July 28, 2009

Subject: Substantial Amendment and Phase 5  
Permit to Construct Application  
Buncombe County C&D Landfill Facility  
Site Hydrogeologic Report, Design Hydrogeologic Report, and Water Quality  
Monitoring Plan  
Response to Review Comments  
Permit No. 11-07

PROJECT NO. 6447-89973  
 FILE NAME: SH1\_2-1.dwg  
 SHEET NO. 2-1

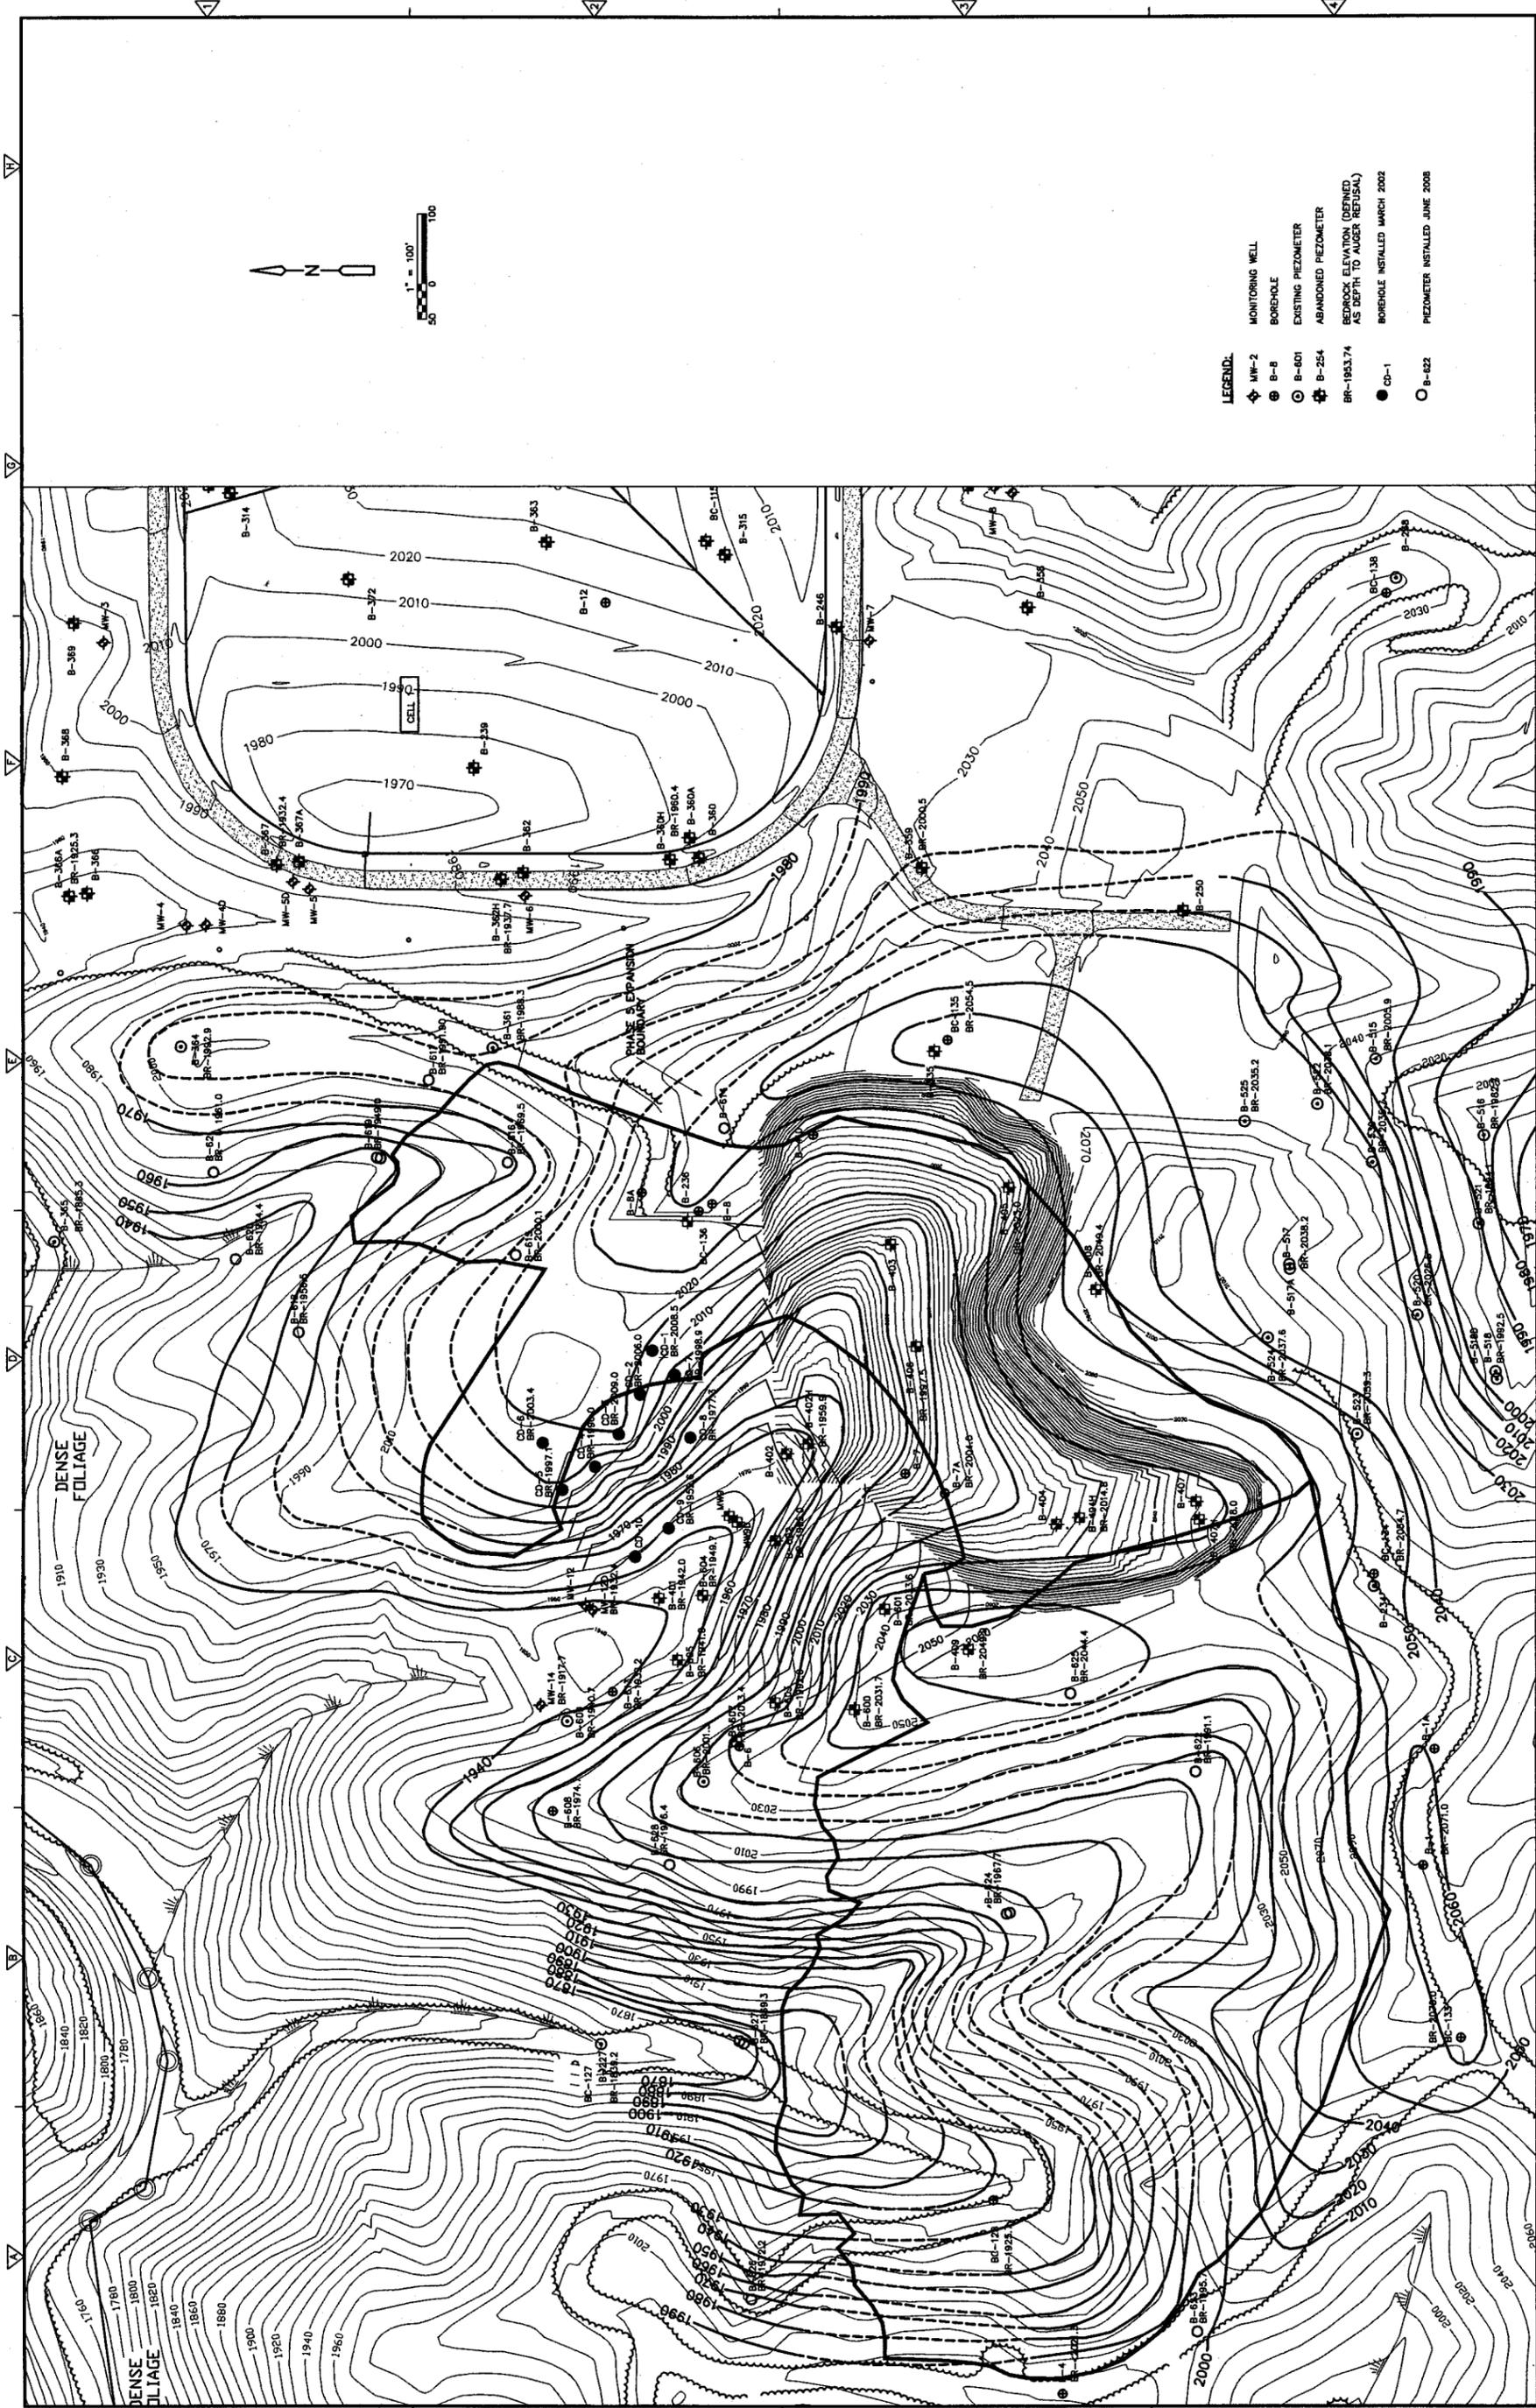
*2.2.2 Correct the sentence where it is stated that "no springs were observed within the ...expansion footprint". Contrary to the report, two springs and streams are shown within the proposed landfill footprint depicted on Sheet 2-1. One is near where cross sections C-C and D-D intersect; the other, along cross section A-A.*

2.14.1.2 Correct the first statement containing "no groundwater discharge points...in the proposed expansion". Depicted on Sheets 2-1 and 2-2 are two springs and streams within the expansion areas proposed for Phase 5.

The statement that no springs were observed within the proposed landfill expansion footprint is correct. In September 2008 CDM performed a stream identification survey for the drainage features within the proposed landfill footprint. The US Army Corps of Engineers (USACE) was then contacted to verify the CDM observations. Based on the CDM observations and the USACE verification, the jurisdictional stream heads were revised. Sheet 2-1 has been corrected to show the revised streams. In addition to Sheet 2-1, all Sheets within the Site Hydrogeologic Report have

been revised, where applicable, to account for the jurisdictional stream revisions. All revised Sheets (2-1 through 2-5) are provided in Attachment 2.

The statement that no springs were observed within the proposed landfill expansion footprint is correct. In September 2008 CDM performed a stream identification survey for the drainage features within the proposed landfill footprint. The US Army Corps of Engineers (USACE) was then contacted to verify the CDM observations. Based on the CDM observations and the USACE verification, the jurisdictional stream heads were revised on the Sheets.

**Figure 2-1**  
**Hydrogeologic Cross-Section A - A' with Groundwater Flow Nets**  
**Buncombe County C&D Landfill Facility Expansion**  
**Site Hydrogeologic Investigation**

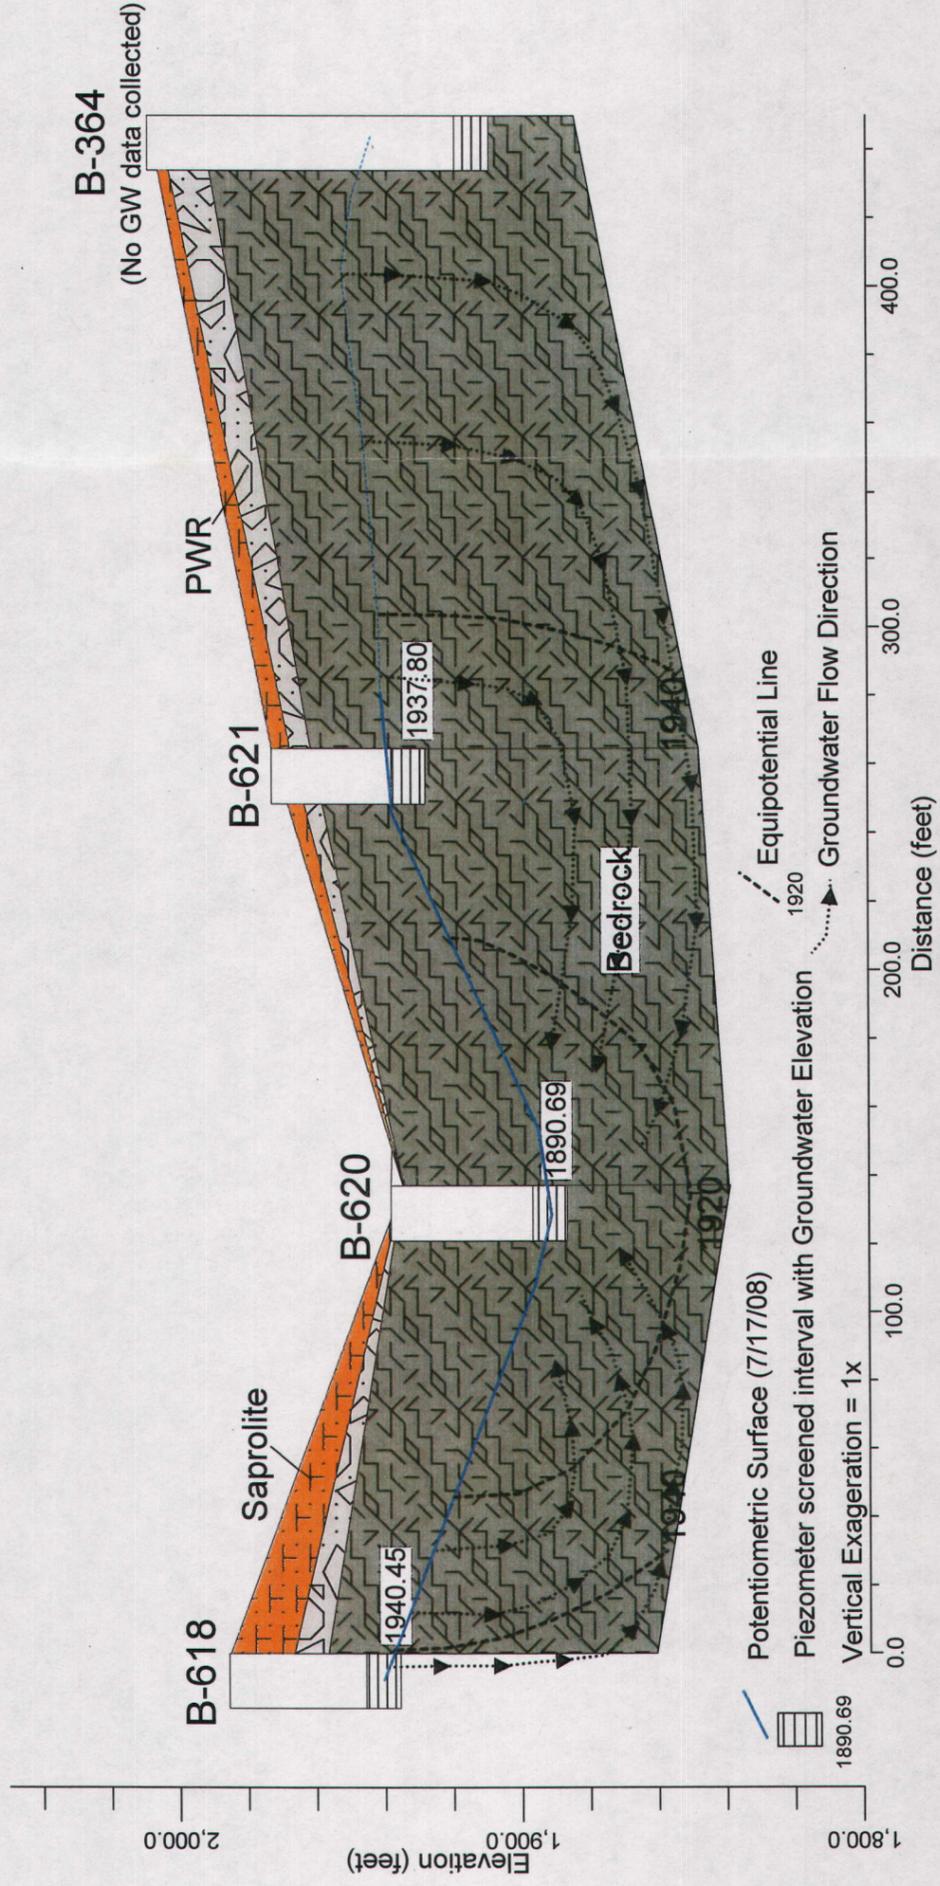
2.7 Provide the groundwater flow nets for stratigraphic sections shown in Figures 2-1 to Figures 2-5 as indicated in the report. Depicted in the sections are lithologic units but not the groundwater flow nets referenced in the site report.

*2-1 to Figure 2-5 Show the groundwater flow net mentioned in Section 2.7.*

Figures 2-1 through 2-5 have been revised to show groundwater flow nets. Revised Figures are provided in Attachment 4.

Figures 2-1 through 2-5 have been revised to show groundwater flow nets mentioned in Section 2.7. The revised figures are provided in Attachment 4.

**Figure 3**  
**Hydrogeologic Cross-Section A - A' with Groundwater Flow Nets**  
**Buncombe County C&D Landfill Phase 5 Expansion**  
**Design Hydrogeologic Investigation**

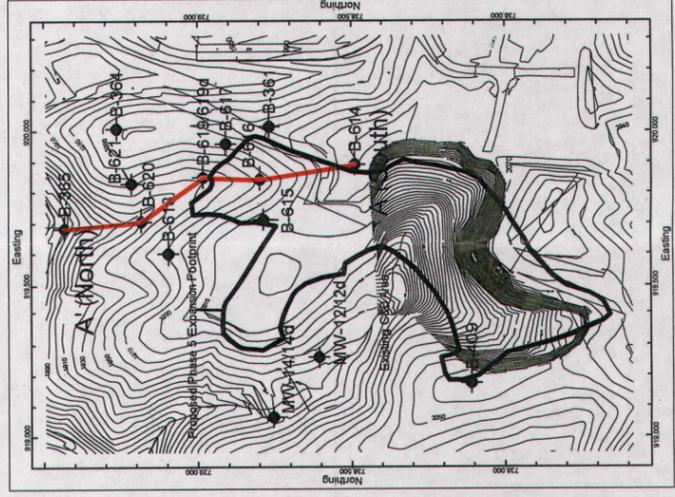
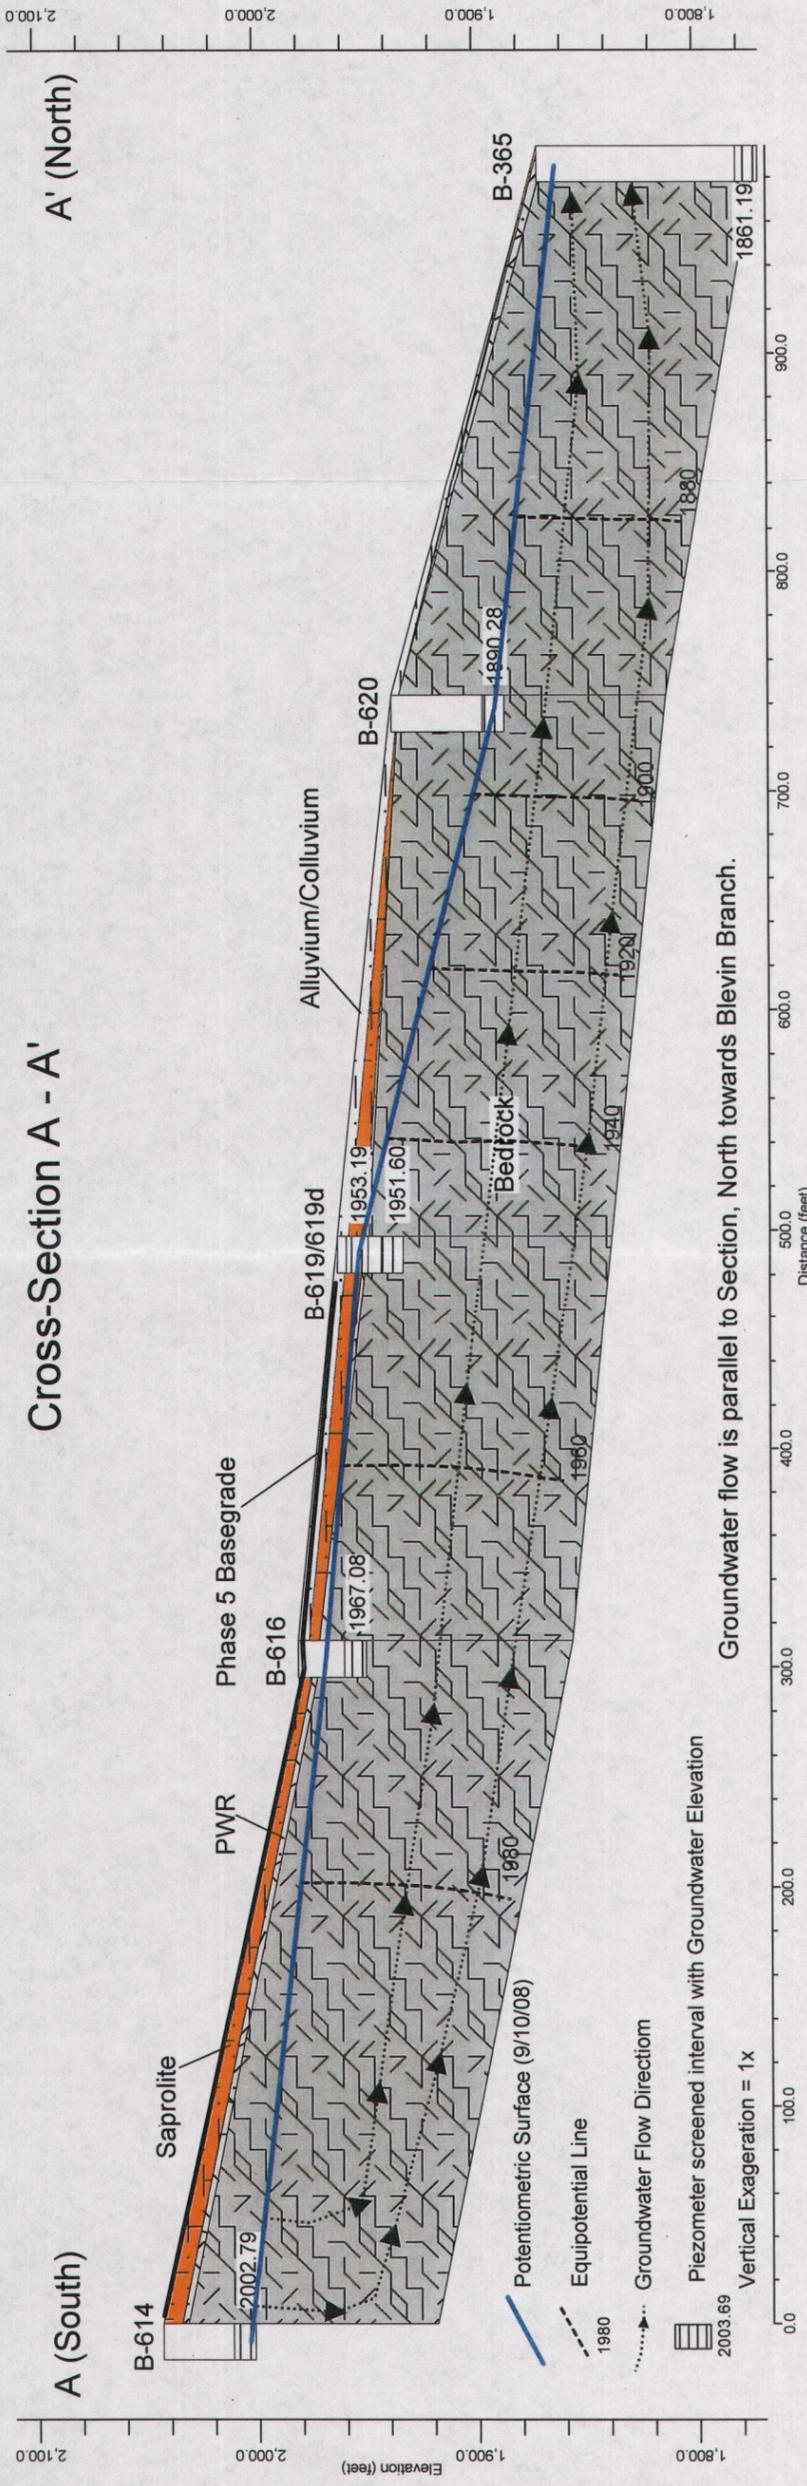
*Figure 3 Show the proposed landfill grades for Phase 5.*

Figure 3 (cross section A-A') has been revised to show the basegrades for Phase 5. As mentioned above, with the exception of topsoil and rootmat and unsuitable soils, there is no planned excavation for the Phase 5 landfill. In addition, Figure 3 has been revised to include groundwater flow nets. Revised Figures are provided in Attachment 7.
